Agenda Date:	June 11, 2026	Application ID:	SP 2026-0001
Project:	Walmart Online Pickup and Delivery	Project Number:	PRJ 2026-0001
Project Planner:	Julia Aldridge, Planner / Zoning Technician		
Owner:	Walmart Stores East LP	Agent:	Andrew Lakowski
Location:	151 SW 184 th Avenue	Commission District:	4
Existing Zoning:	PUD (Planned Unit Development)	Existing Land Use:	Commercial
Reference Applications:	SP 97-25, ZV 2002-33, SP 2002-28, MSC 2018-08, MSC 2019-12, ZV 2024-0006, ZV 2025-0004, MSC 2026-0001		
Applicant Request:	+/- 6,749 of existing garden center to be converted to storage space for online pickup and delivery services		
Staff Recommendation:	Approval		
Final:	<input checked="" type="checkbox"/> Planning & Zoning Board	<input type="checkbox"/> City Commission	
Reviewed for the Agenda:	Director: 	Assistant Director:

Date: April 8, 2026
To: SP 2026-0001
From: Julia Aldridge, Planner / Zoning Technician / Cole Williams, Senior Planner
Re: Walmart Online Pickup Addition

**TO: Cole Williams, AICP, Senior Planner & Julia Aldridge, Planner/Zoning Technician
Planning and Economic Development Department**

DRAWN	JW
CHECKED	JW
DATE	05/17/2026
SCALE	AS NOTED
JOB No.	342045701
SHEET	DM-1

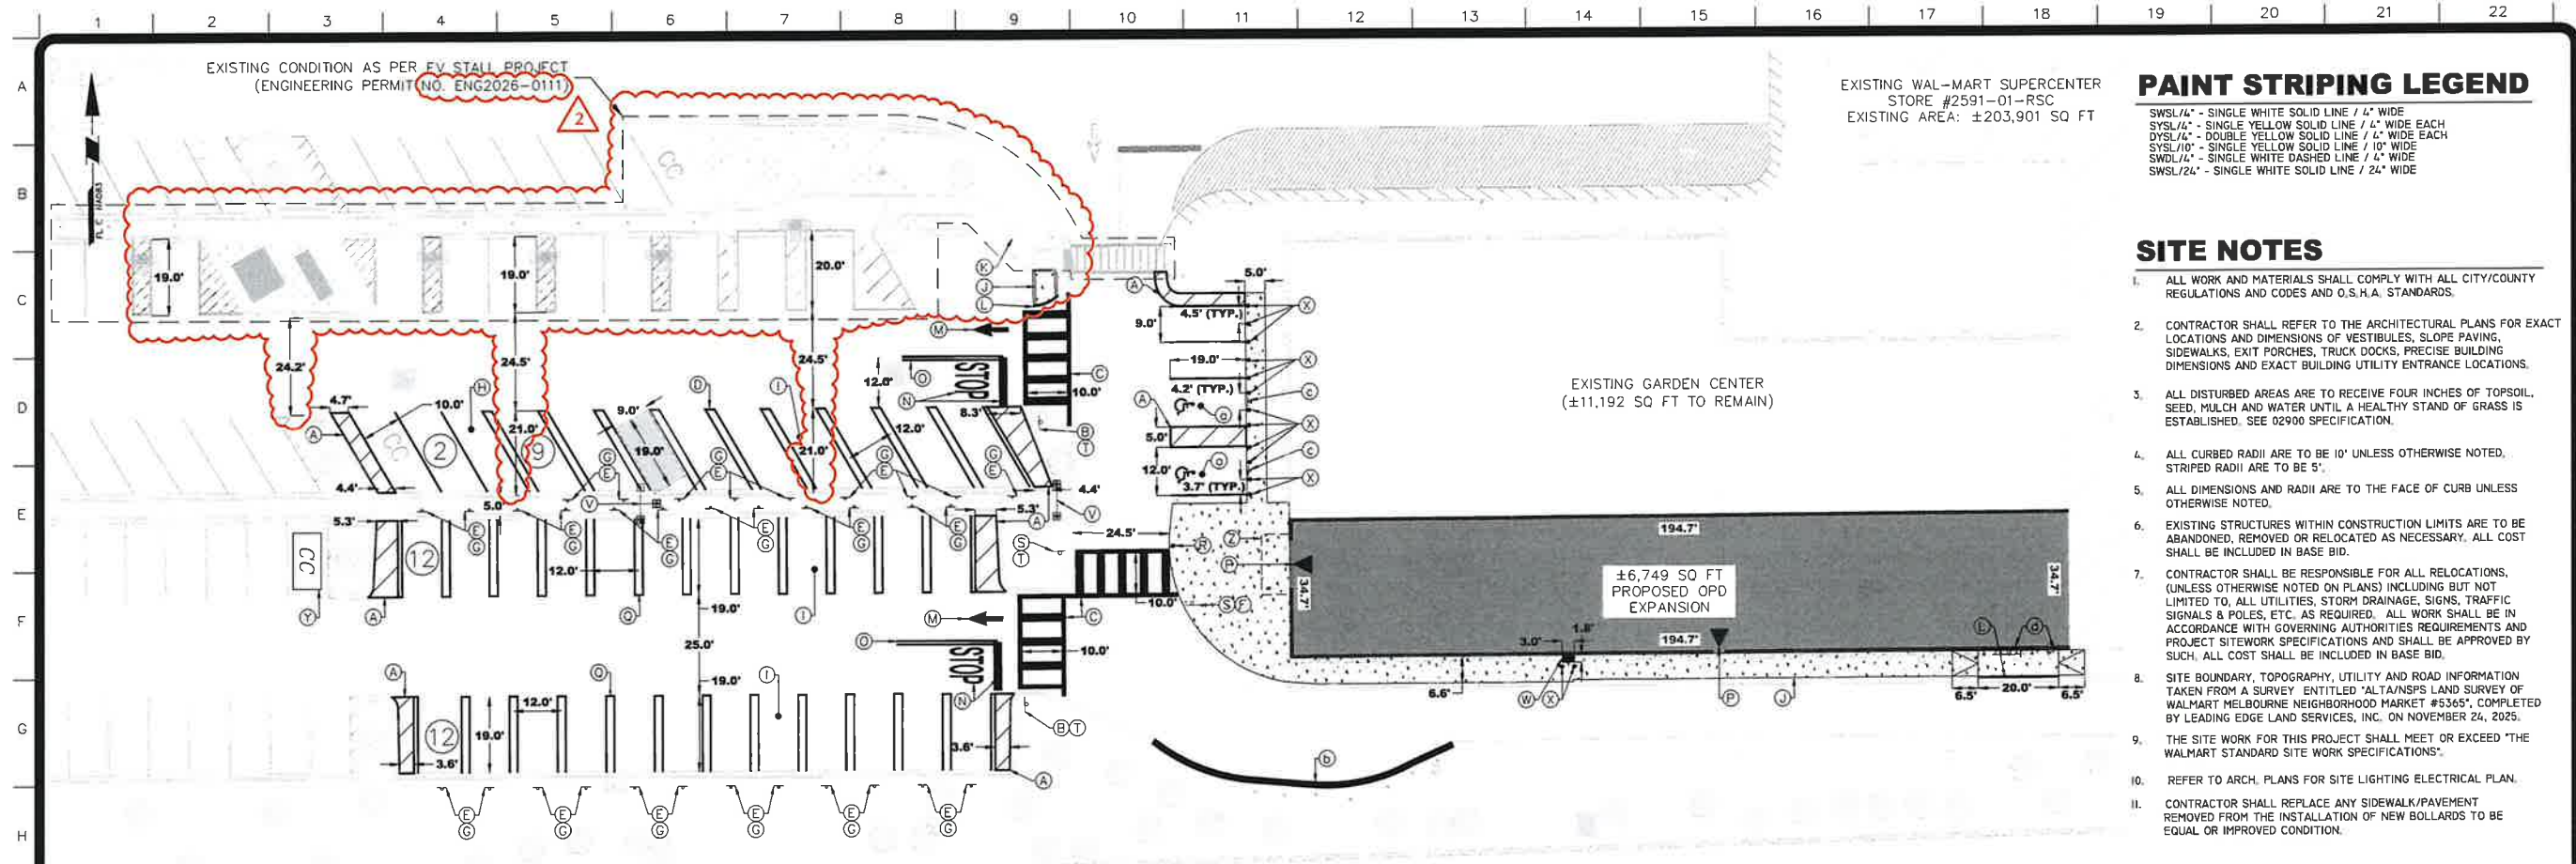
2. Paving & Demolition Plan, Sht. DM-1 – Accessible and Standard Parking Spaces must comply with the City’s Engineering Standards R-32, ‘Accessible Parking Space Details’ and R-41, ‘Standard Parking Space Details’. Typical Accessible and Standard Parking Spaces are required by Code and Engineering Standards to be a minimum of 19’ in length with a Wheel Stop placed at 3’ from the front edge of pavement or Type ‘D’ Curb along the front of the parking space/area. For Accessible and Standard Parking Spaces (existing and/or proposed) with flush sidewalk/walkways abutting the front of the parking spaces, Wheel Stops or Vehicular Protective Bollards in accordance with City Standard R-32, Sheet 3 of 4 and R-41, Sheet 2 of 3, must be provided for pedestrian protection.

Existing Bollards along the front of the existing parking spaces with flush sidewalk/walkway along the front of the parking spaces abutting the west side of the existing Outdoor Garden Center area to remain do not conform with the maximum permitted spacing per City Standard R-32, Sheet 3 of 4 and R-41, Sheet 2 of 3.

3. Paving & Demolition Plan, Sht. DM-1– All existing and proposed vehicular and pedestrian traffic sign assemblies and pavement markings within the project limits and the parking access lane abutting the west side of the existing Outdoor Garden Center area to remain must comply with Broward County Traffic Engineering Division (B.C.T.E.D.) and Manual of Uniform Traffic Control Devices (M.T.U.C.D.) standards, as adopted by the city per City Code and as required by City Engineering Standards

4. Paving & Demolition Plan, Sht. DM-1– Pavement markings for the existing Standard and Accessible Parking Spaces abutting the west side of the existing Outdoor Garden Center must be refurbished/restriped to comply with City Standard R-32 and R-41. Pavement markings along the west side of the westernmost Standard Parking Space must be restriped to reflect ‘6” White Edge Lines w/8” White Diagonals at 5’ O.C.’ per City Engineering Standards

5. Paving & Demolition Plan, Sht. DM-1 – Provide for removal of the appropriate section of the existing Type ‘F’ Curg & Gutter to allow for construction of new section of Concrete Sidewalk for connection to the Concrete Sidewalk being constructed under the EV Charging Station project per City Engineering Permit Application APP2025-0149.

DRAWN	DOPL/SZ/PC
CHECKED	JUY
DATE	03/17/2026
SCALE	AS NOTED
JOB No.	342045701
SHEET	C-2

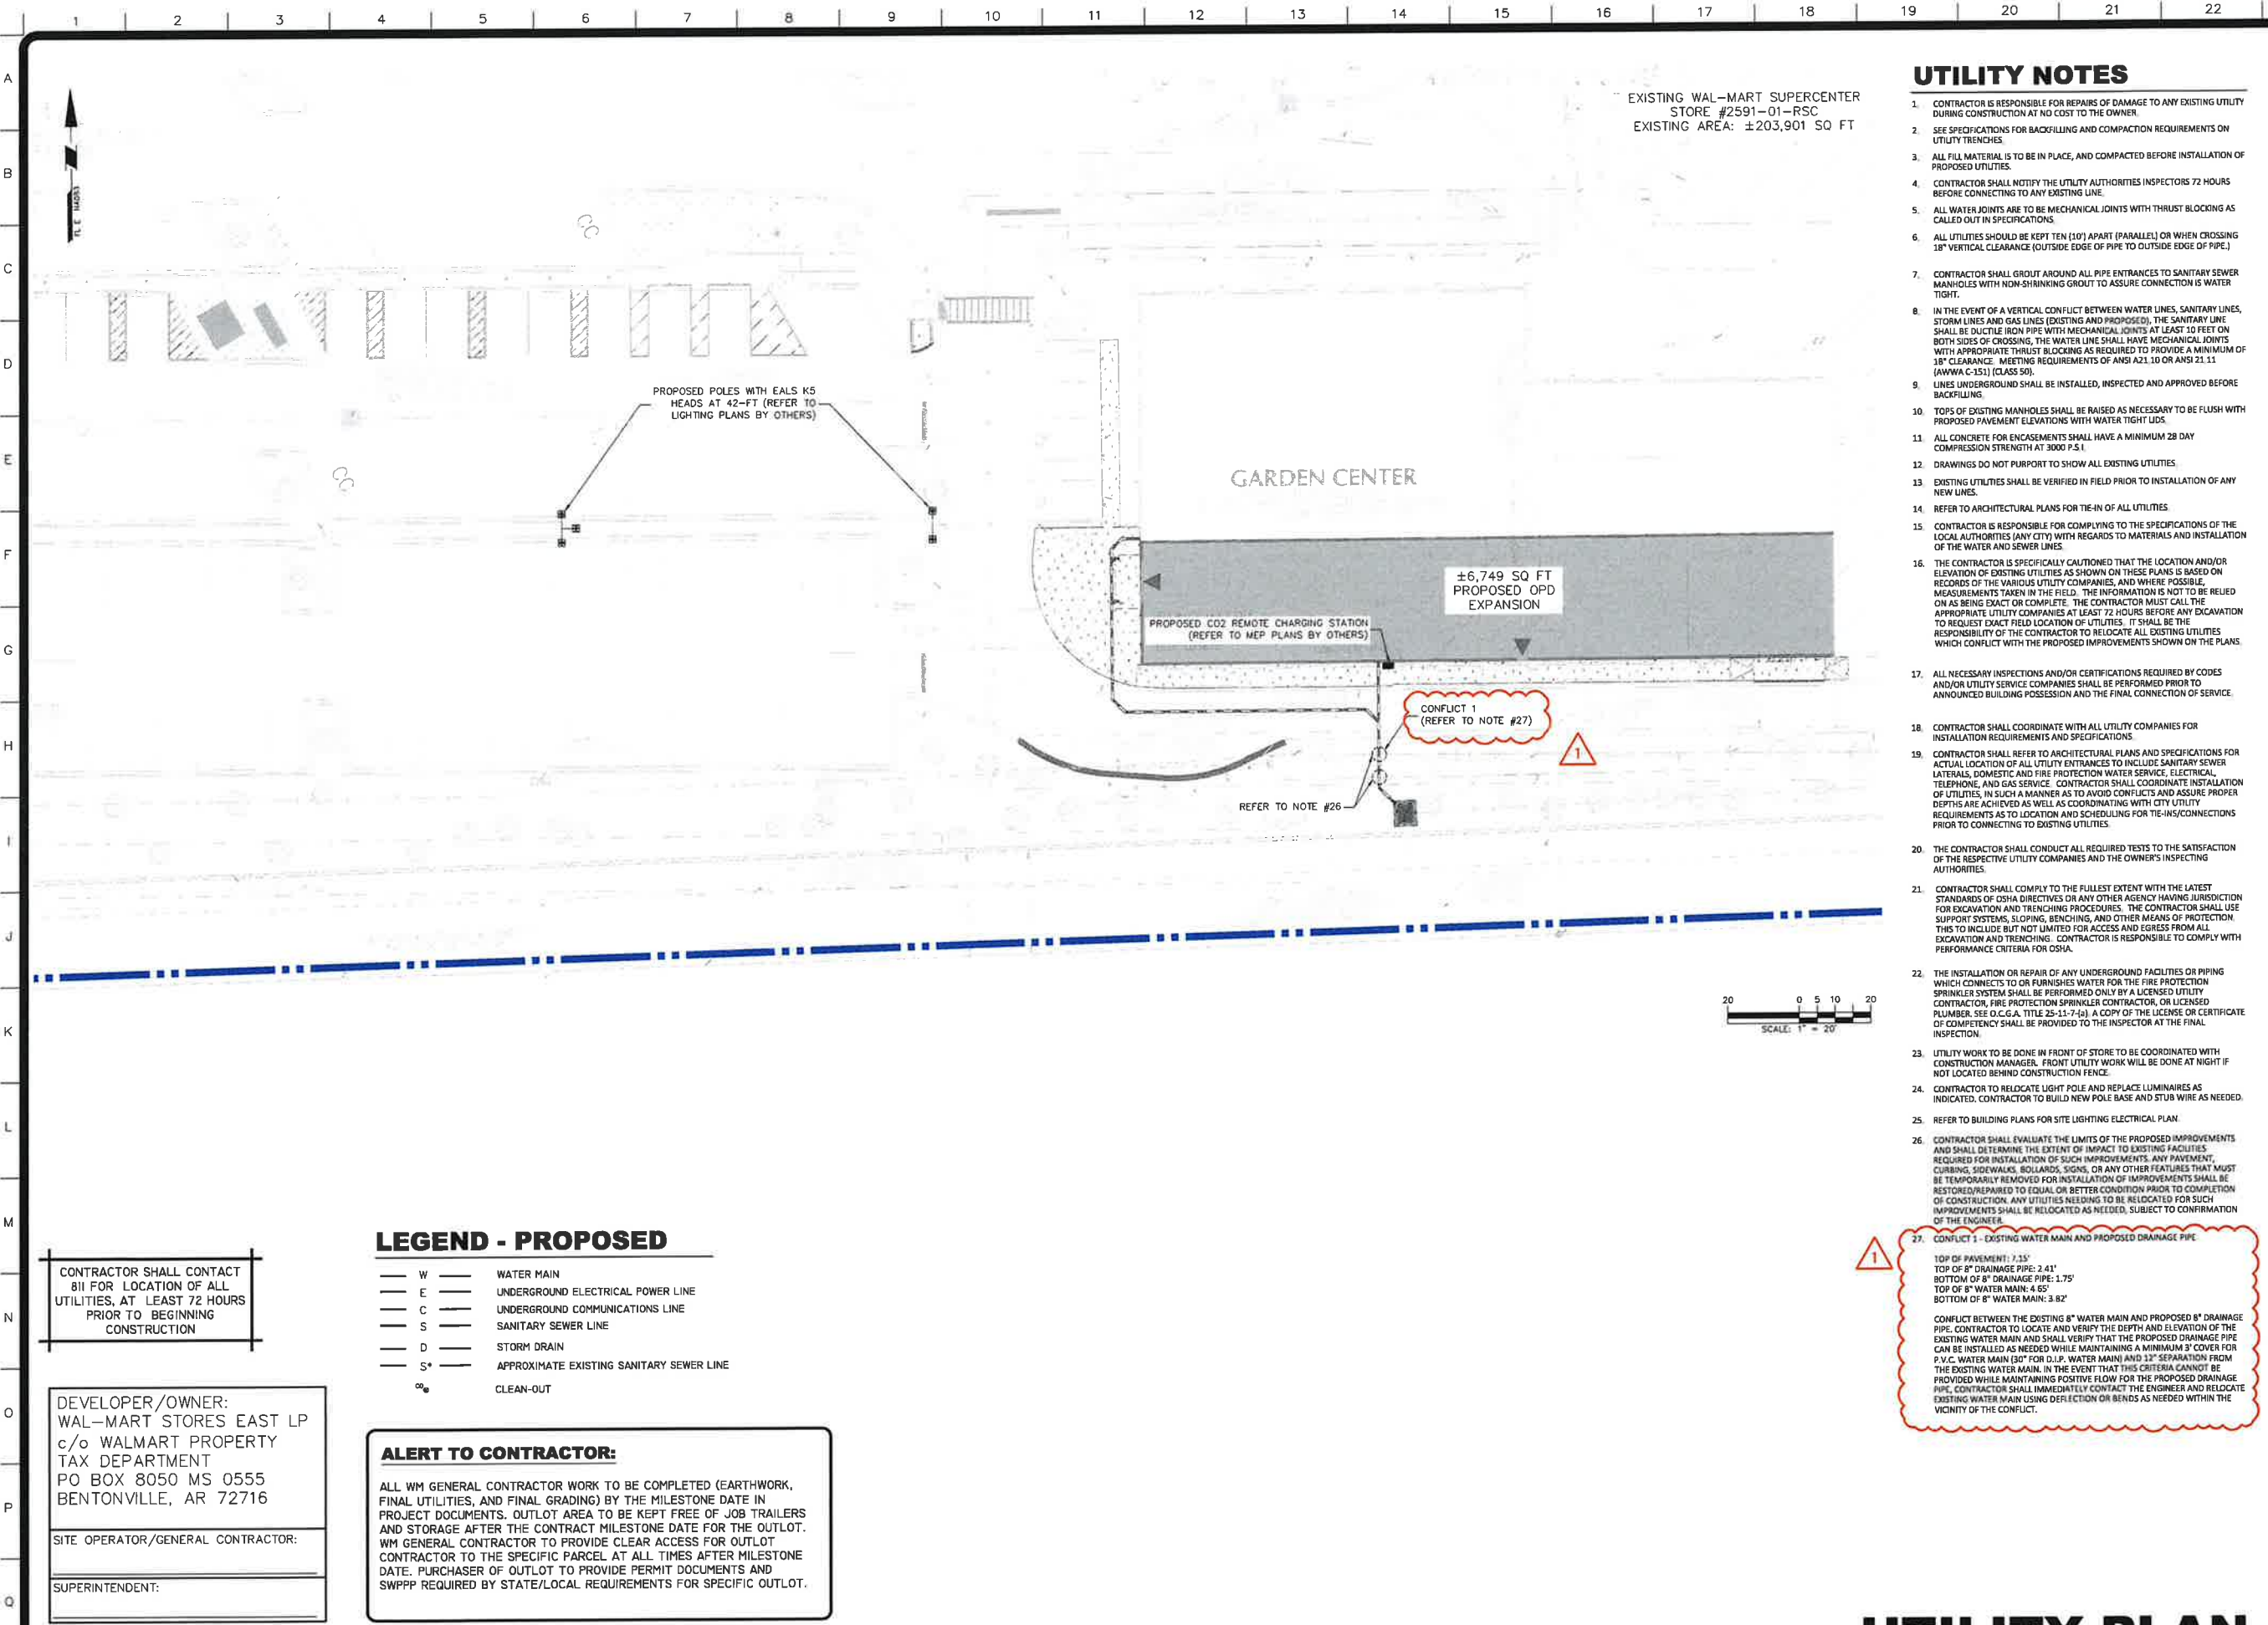
19. Grading and Drainage Plan, Sheet C-2 – Provide Crossing Data for the crossing of the proposed 8” HDPE Roof Drainage Line and the city’s existing 8” water main.

20. Grading and Drainage Plan, Sheet C-2 – If the existing Utility Easement shown running through the footprint of the proposed new building addition has not been previously vacated, then this Utility Easement must be vacated preferably prior to issuance of the building permit for the new building addition.

21. Grading and Drainage Plan, Sheet C-2 – Accurately depict and denote/label on the plan the required Pavement Restoration for installation of the proposed 8” HDPE Roof Drainage Line per City Standard R-38.

DRAWN: DOUGLASS
CHECKED: LUY
DATE: 03/17/2028
SCALE: AS NOTED
JOB No.: 342045701
SHEET: D-1

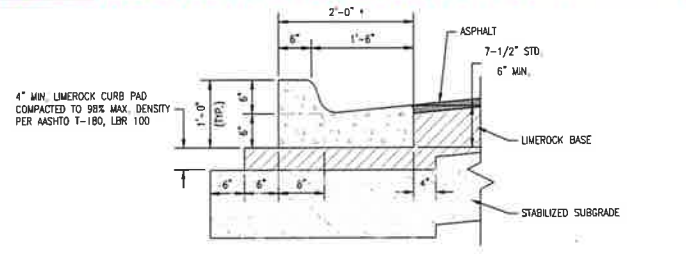
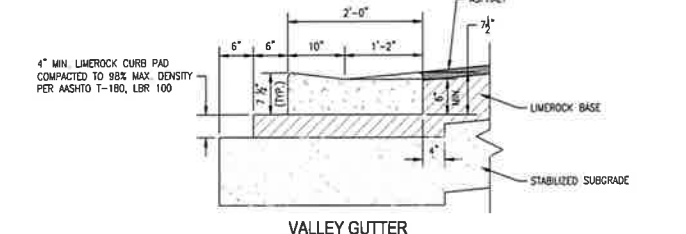
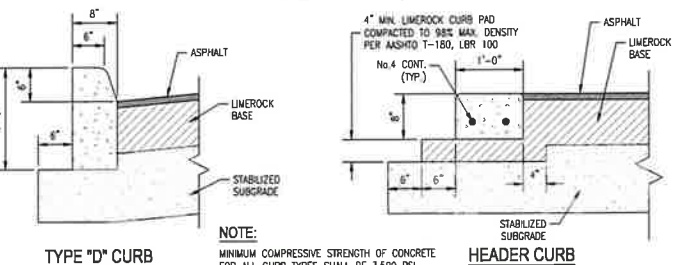
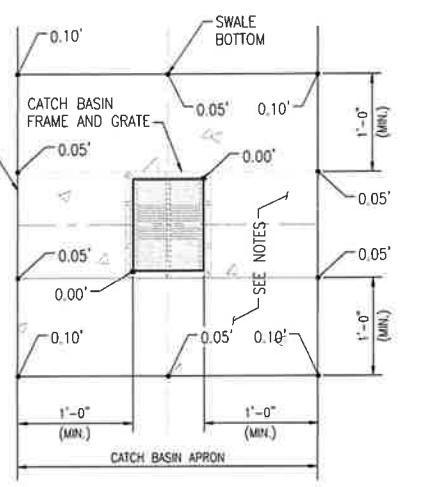
23. Site Details, Sheet D-1v– ‘Operational Signage’ is not typically permitted as part to the Engineering Permit scope of work. A separate permit is typically processed through the building department for operational related signage. Delete all ‘Operation Signage’ related details and notes for the Site Details sheet.

24. Site Details, Sheet D-1 – Revise the ‘Parking Stall 18’ detail’ and the OGP Crosswalk Marking Detail’ per the mark-ups reflected on the details sheet.

25. Site Details, Sheet D-1 – The Site Details sheets are required to include the following attached three (3) B.C.T.E.D. pavement markings and signage related details sheets:

DRAWN	
CHECKED	
DATE	05/19/2026
SCALE	
AS NOTED	
JOB No.	342045701
SHEET	D-2

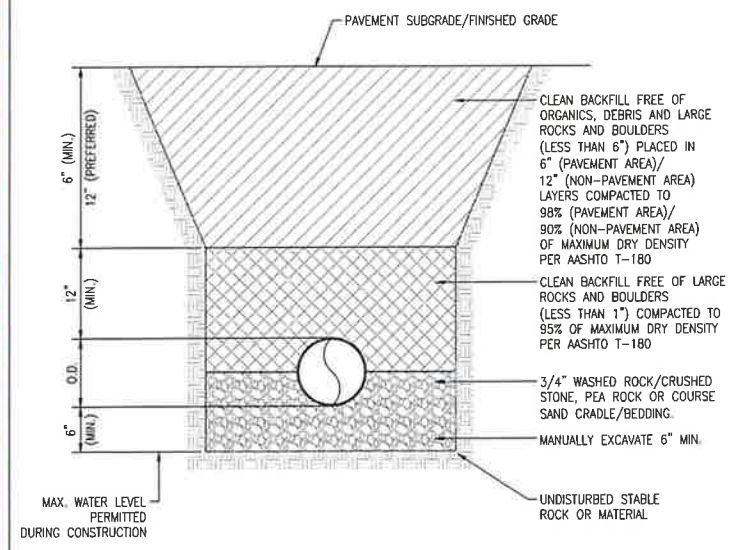
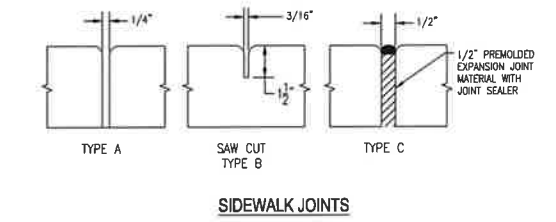
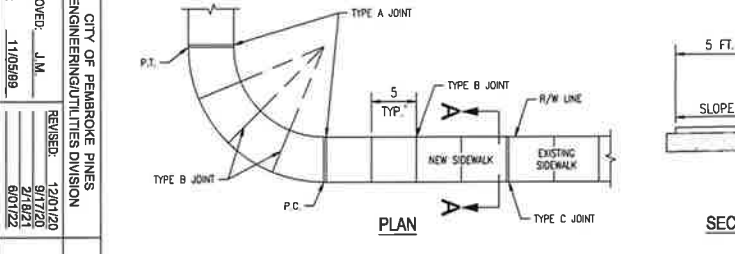
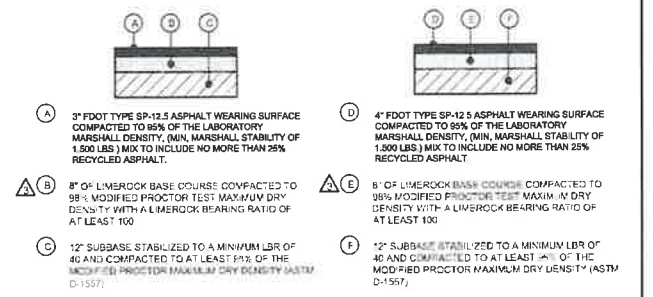
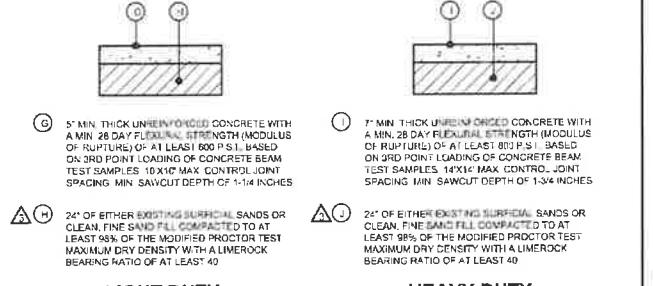
- ‘Ground Sign Assembly Details’
 - ‘Pavement Marking and Signage Details’
 - ‘Stop Sign and Street Identification Assembly Details’
26. Site Details, Sheet D-2 – Asphalt Wearing Surfaces are required to be SP-9.5 or SP 12.5 or a F.D.O.T. permitted combination of the two with a minimum thickness Limerock Base of 8” per City Engineering Standards.

27. Site Details, Sheet D-2 – City Standards must reflect their entire detail sheet, including the City’s Title Block information to allow for confirmation that the detail is the latest revised version of the detail.

28. Site Details, Sheet D-2 – The following additional City Standards must be reflected on the Site Details sheets:
 - R-32, ‘Accessible Parking Space Details’, Sheet 1, 3 & 4 of 4
